ADDENDUM NO. TWO (2)
TOWN OF BRASELTON, GEORGIA
2026 GROUNDWATER EXPANSION AND DISTRIBUTION STORAGE
ISSUED JANUARY 23, 2026

RE: 2026 GROUNDWATER EXPANSION AND DISTRIBUTION STORAGE
EMI PROJECT No. 18-021

The purpose of this Addendum is to provide the omitted storage tank drawings, existing contours for treatment site, the pre-bid meeting attendance, and add Precon Corporation as a pre-approved concrete storage tank manufacturer. The following items of the Contract Documents are modified as part of this Addendum:

M7

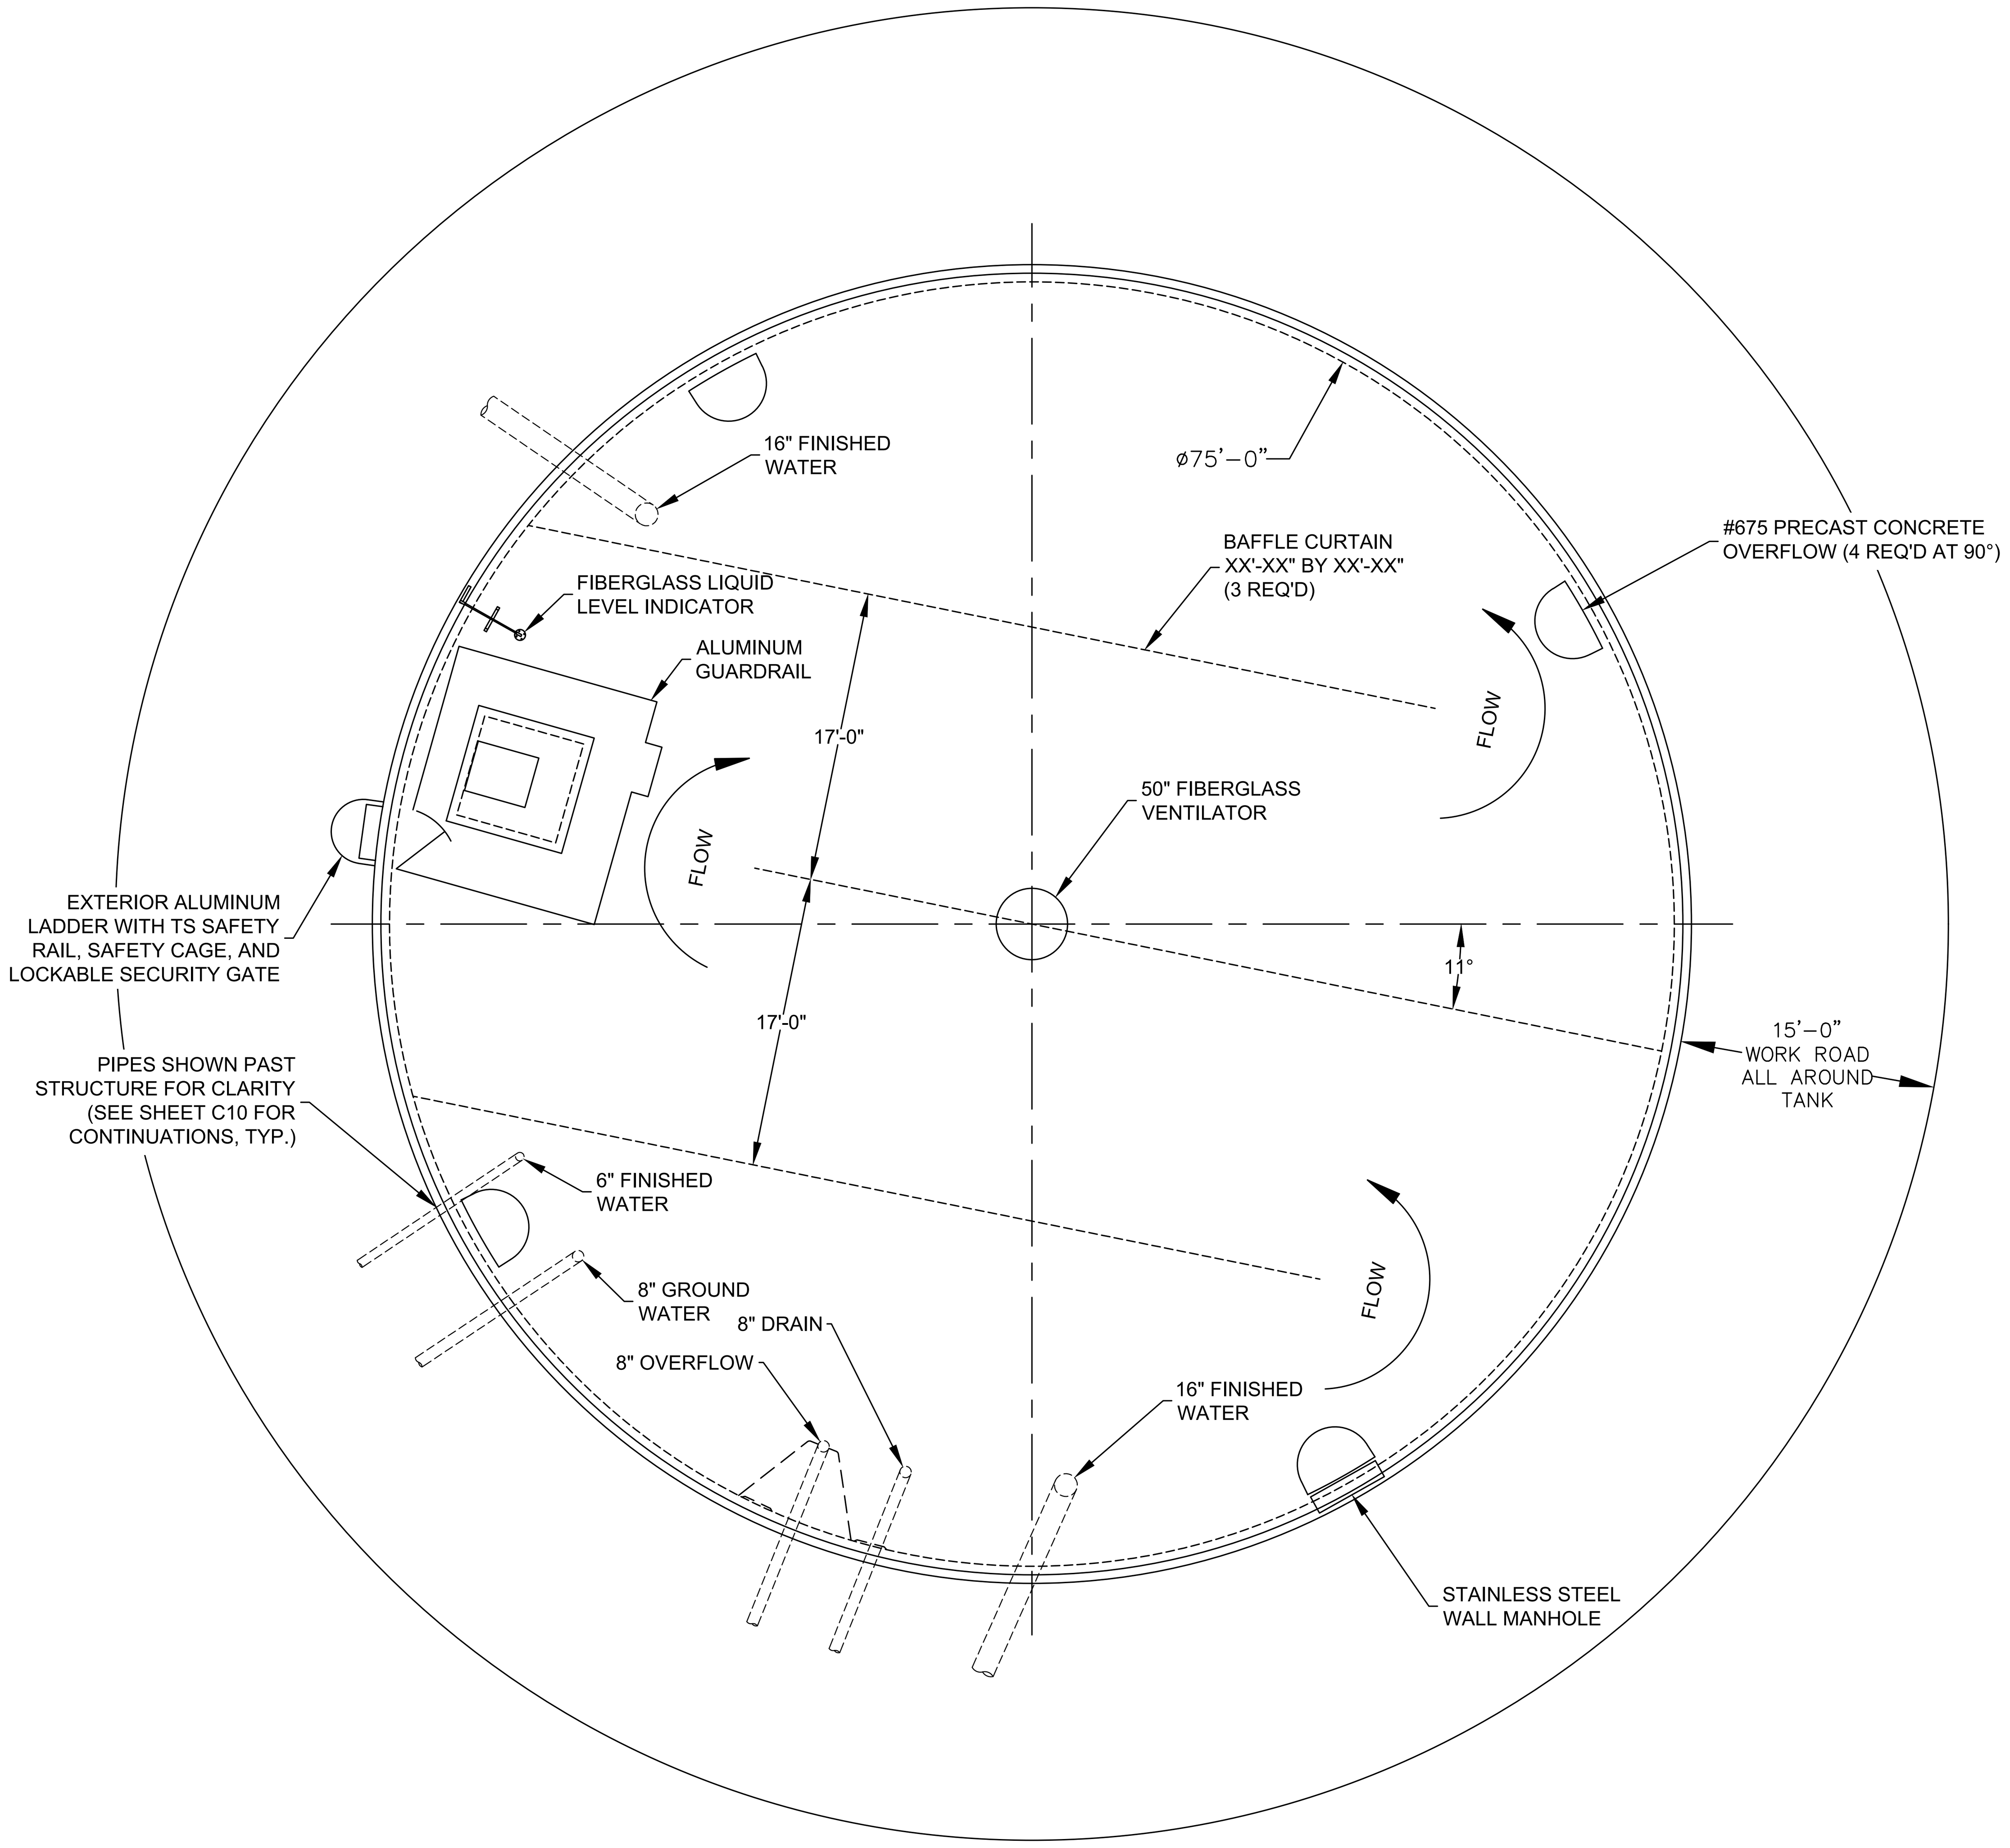
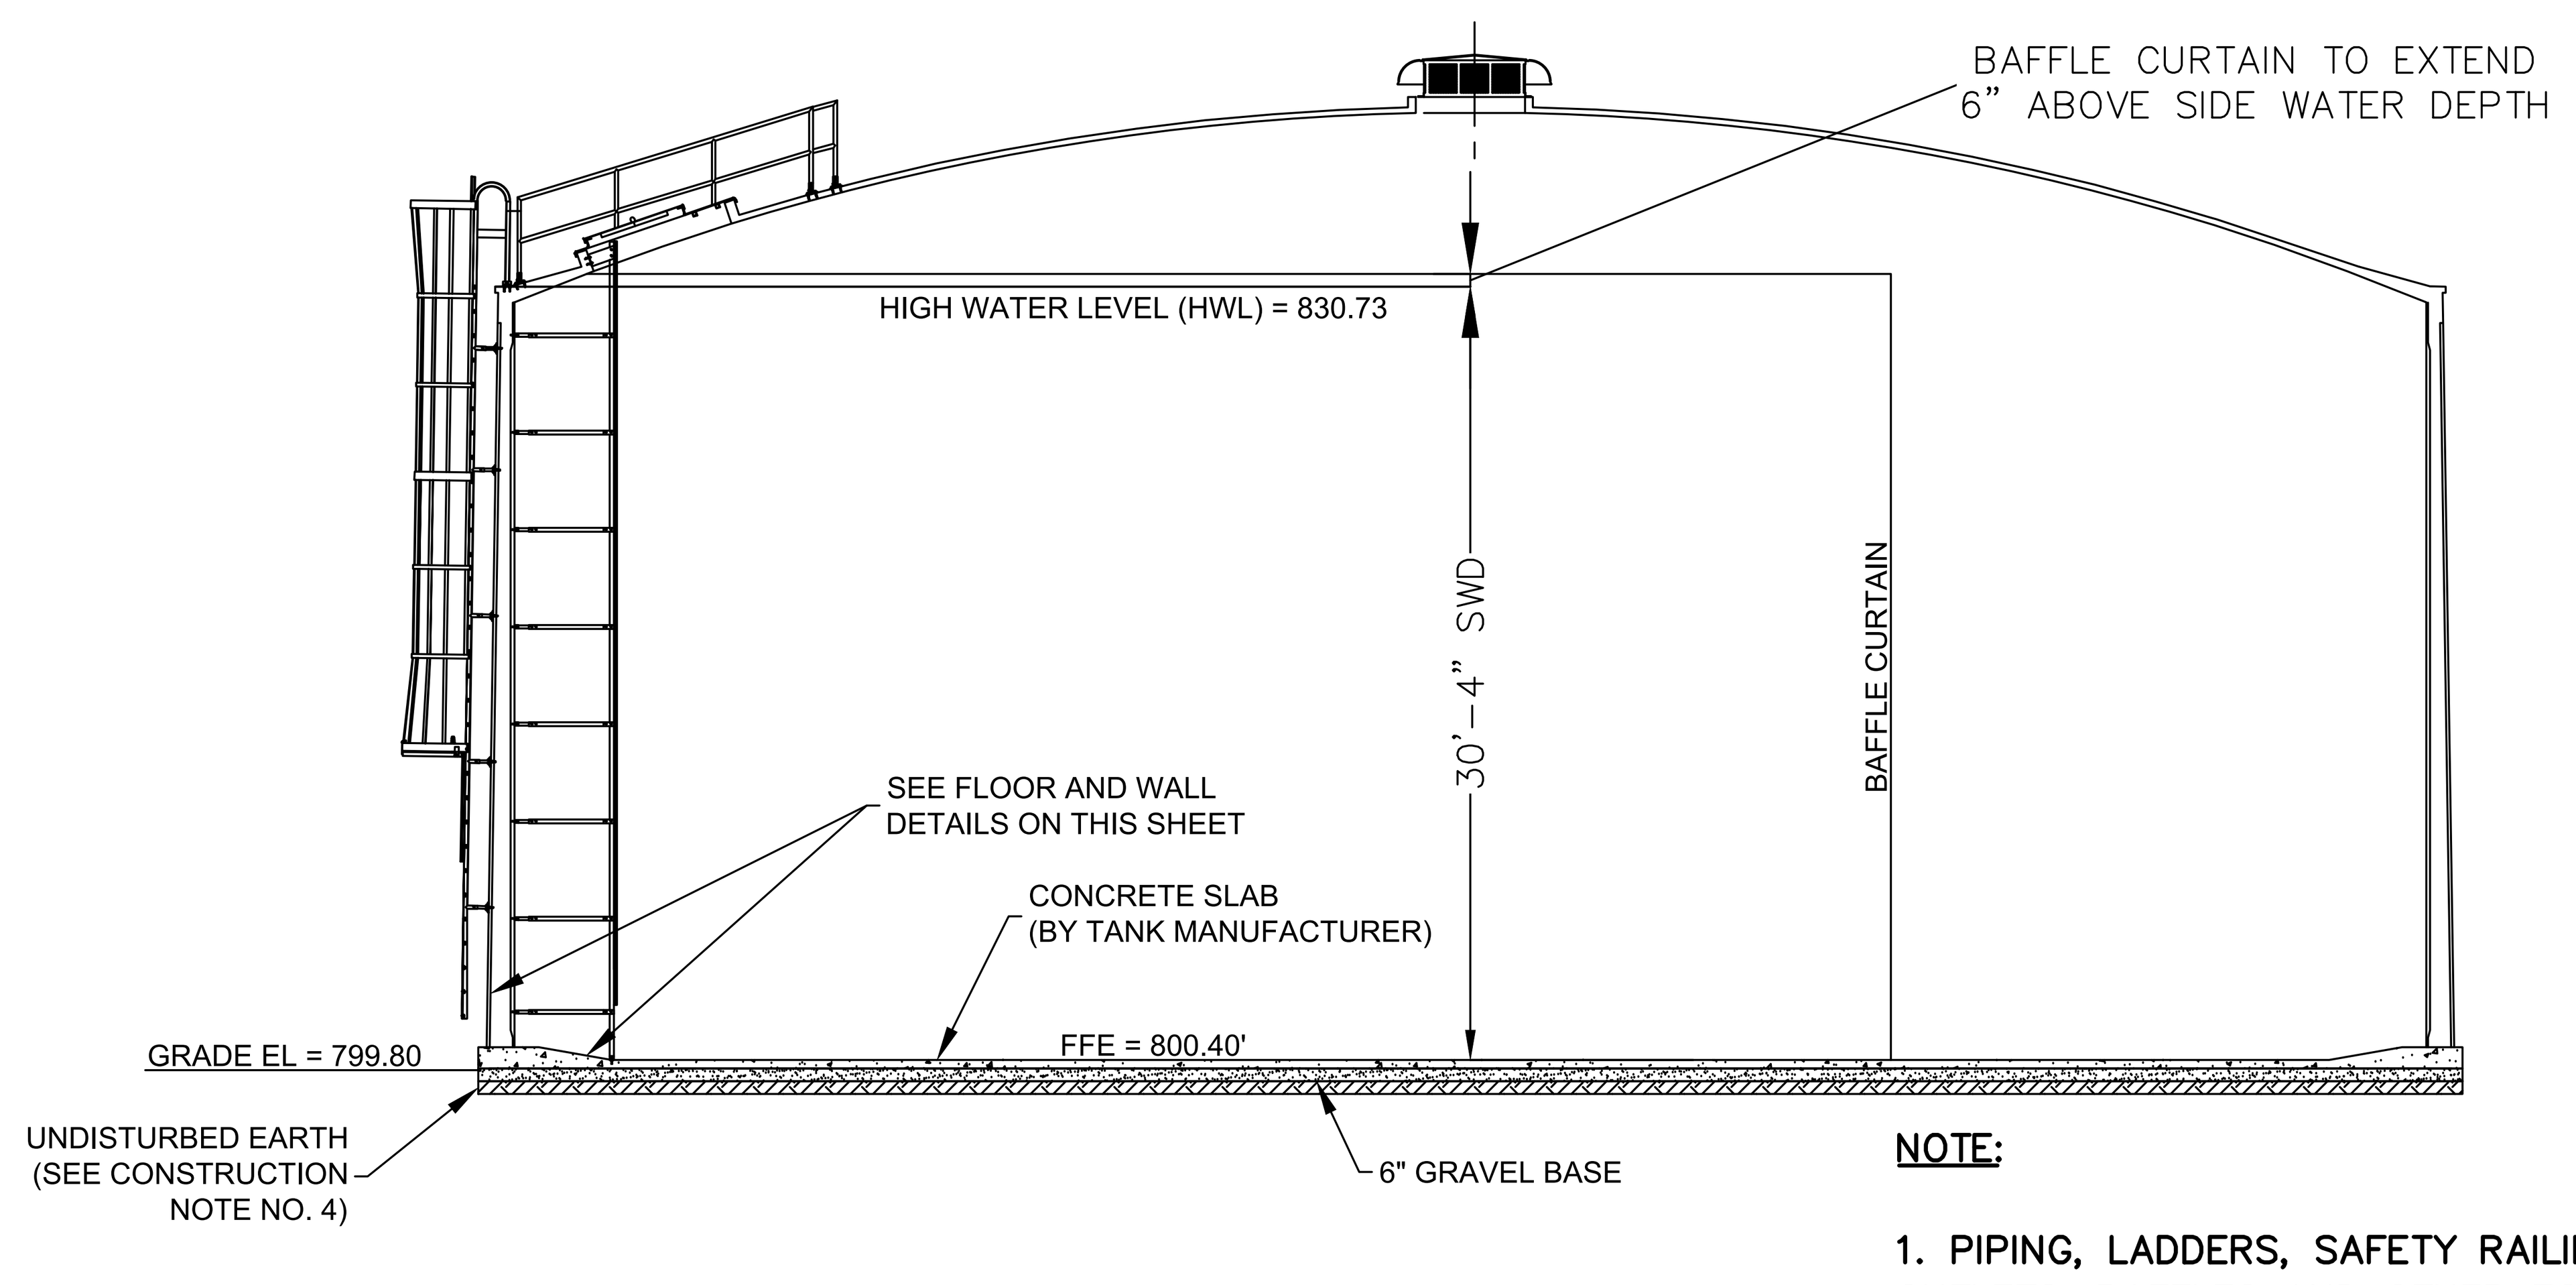
1. The contract documents appear to be missing plan sheets M7-M10 for the new tank listed in the sheet index. Can you please provide the missing drawings?

- <u>*Plan sheets M7-M10 have been provided to show plans for the concrete storage tank. See attached plan sheets.*</u>

EMI Response: Sheets M7-M10 were omitted in error. Please see the original sheets attached to this addendum.
